**PROJECT:** Waitsfield BRF 013-4(39) - Bridge No. 177  
VT Route 100 over Mad River

**RE:** RFI #3. Back Wall Reinforcing Layout

### RFI #3: Back Wall Reinforcement Layout

Contract Drawing 45 of 69 excerpt

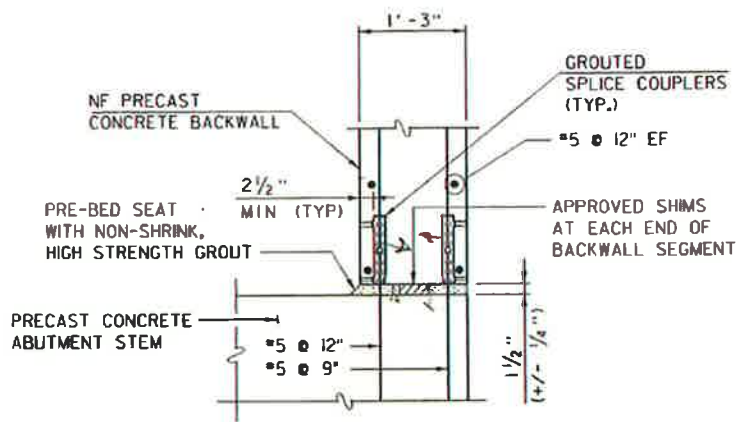
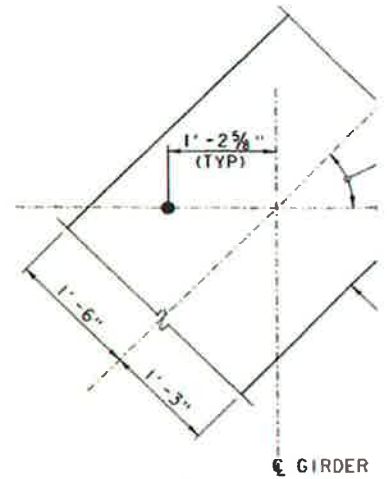
Contract drawings, including the attached detail excerpt on sheet 45 of 69, show 2 ½" clear cover from the face of back wall concrete to the edge of the splice sleeves, however, transverse reinforcement is shown on the outside of the sleeves and U-shaped reinforcement at the top of the back walls is shown outside of the transverse bars which violates the 3" cover requirement stated in the contract drawings. JPC assumes that the contract drawing clear cover of 3" on reinforcement applies to the U-shaped bars, and other reinforcement is laid out inside of this reinforcement which results in grouted splice sleeves that are laid out only 5 ½" center to center and only 11 ½" center to center for Abutment #2 and Abutment #1 respectively, as shown on the attached.

**Response:** MJ has reviewed the attached details, and agree with the reinforcing clearances as detailed in the proposed alternatives. MJ recommends that the transverse reinforcing above the grouted splice sleeve connectors be placed on the outside of the vertical reinforcing steel (see attached sketch).

Waitsfield VT Bridge  
JPC RFI #3 Attachment  
Abutment #2 Backwall  
Reinforcement Section

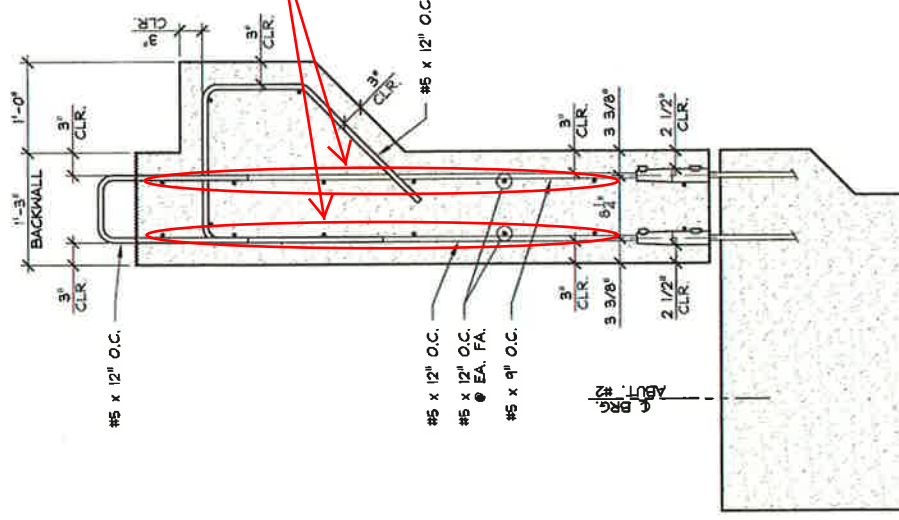
JPC submits the attached back wall reinforcing sections for Abutment #2 and Abutment #1 to show the reinforcement layout in back walls based on the contract drawings and to propose alternative reinforcement layouts for each case. The alternative proposals place the transverse reinforcement inside of the splice sleeves and increase the center to center spacing between splice sleeves which may be more desirable for design.

JPC requests confirmation on the intended detailing approach for the layout of reinforcement in the back walls.
